ITEM FOR ENVIRONMENTAL BOARD AGENDA

PROJECT NAME: Block at 26th Street

SITE PLAN: SP-2011-0032C.SH

REQUEST: The applicant is requesting to remove a heritage tree with a stem greater than 30 inches as allowed under LDC 25-8-643

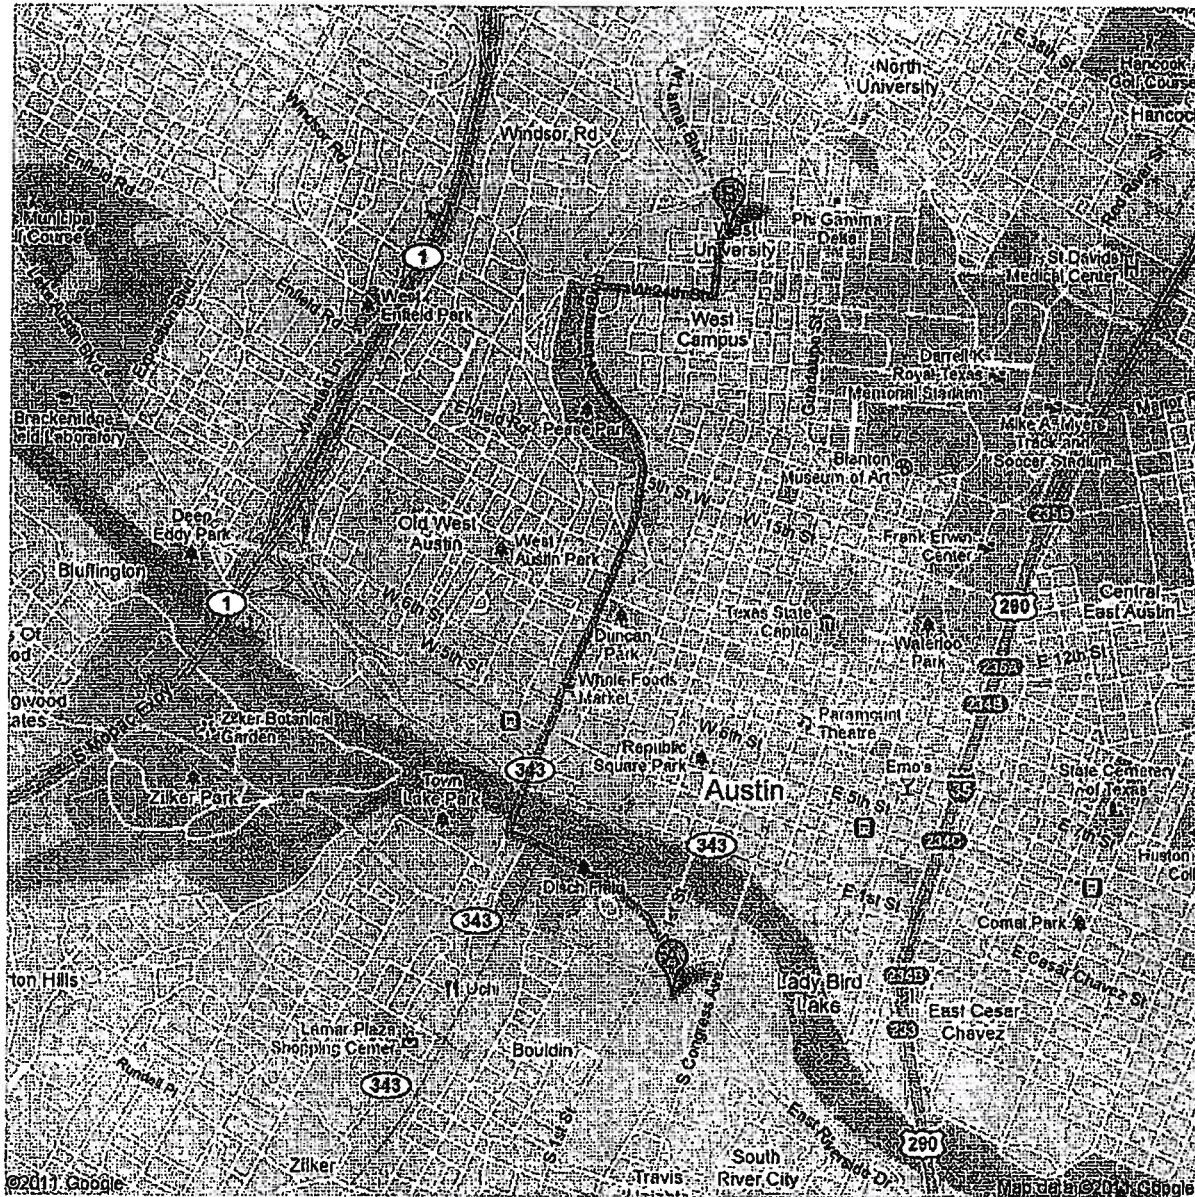
The following information is being provided in regards to tree no. 1893 on the attached site plan sheet for the Block at 26th Street project. Removal of the 30 inch pecan is being requested. We hereby ask that the variance request be placed on the June 1, 2011 Environmental Board agenda and the June 14, 2011 Planning Commission agenda.

The site plan for this project proposes removal of tree no. 1893 for several reasons, as listed below:

1. The proposed driveway on West 26th Street aligns with Pearl Street, as shown on the attached site plan sheet 3. According to Section 5.3.1.K of the Transportation Criteria Manual, "[a]ll Type II and III driveways on undivided collector streets shall be designed to align with opposing streets or driveways or be offset by a minimum of 80 feet (measured from edge to edge)." Alignment of the driveway with Pearl Street is the optimal multi-modal configuration, since pedestrians, bicyclists, and vehicles would expect a four way approach and are used to handling that traffic situation. Offset driveways create an additional location for pedestrian, bicyclist, and vehicular conflict.

2. The proposed driveway on West 26th Street is in the same location as the existing driveway. Therefore, the critical root zone is already impacted by the existing driveway and sidewalk.

5. Overall, approximately 90 caliper inches of trees will be removed onsite. However, approximately 100 caliper inches of trees are proposed to be planted as part of the streetscape within the ROW, as shown on attached site plan sheets 3 and 7. Location of the newly planted trees within the streetscape will place more appropriate types of urban trees in the area.

Exhibit #2

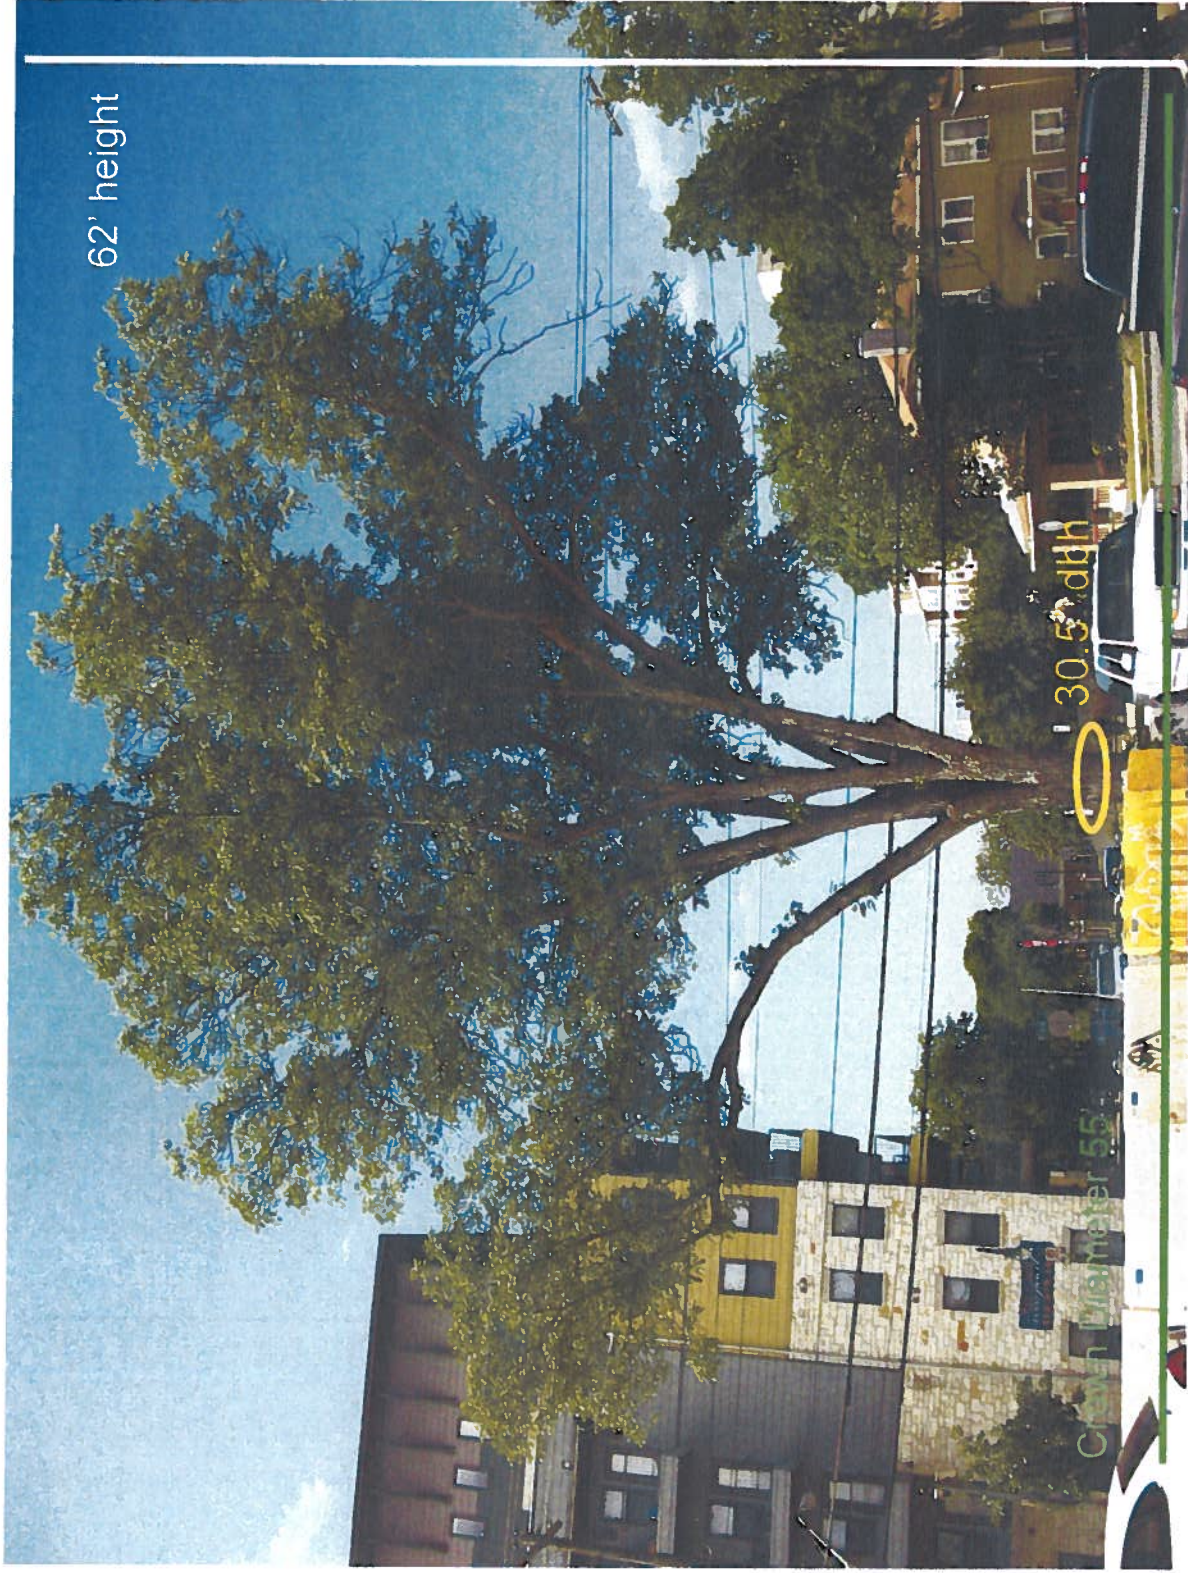
The subject tree is a 30.5 inch diameter at breast height (dbh) Pecan (*Carya illinoensis*). The tree height is 63 feet and the canopy spread is 55 feet (Exhibit 2). The trunk bifurcates into two co-dominate stems at eight feet above grade (Exhibit 3). Storm damage is evident by the presence of broken stems, though no noticeable decay or structural weaknesses are present (Exhibit 4). Minor pruning has occurred for utility clearing and likely from storm damage. There is minor deadwood and tip dieback in the crown though this is not uncommon in *Carya illinoensis* (Exhibit 5). This condition is likely exacerbated by poor soil and extensive compaction in the critical root zone (Exhibit 6). Given the aforementioned conditions, the subject tree is rated 'good' per the City Arborist tree evaluation (Exhibit 7).
